**Timbers at Black Forest
Letter of Intent**

Tax Schedule No: 5222000025
Acreage: 55.707 acres
Current Zoning: RR-5 (Residential Rural)
Requested Zoning: RR-2.5 (Residential Rural)

Letter of Intent.pdf Markup Summary

Below is a map depicting the surrounding development and zoning:

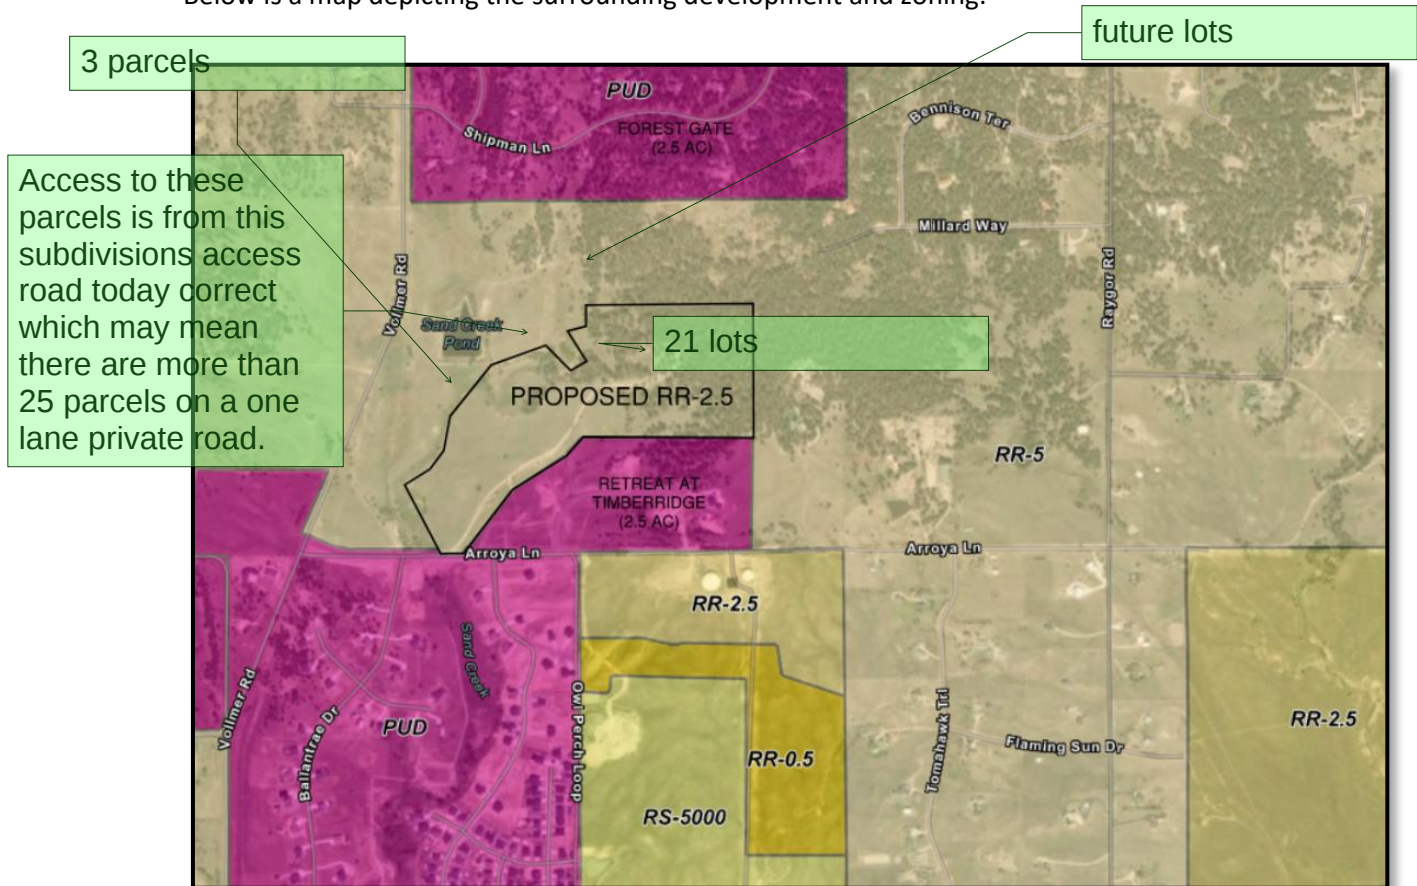
Subject: Planner Page Label: 3 Author: dsdparsons Date: 8/17/2026 11:43:18 AM Status: Color:  Layer: Space:	Access to these parcels is from this subdivisions access road today correct which may mean there are more than 25 parcels on a one lane private road.

21 lots

3 parcels

future lots
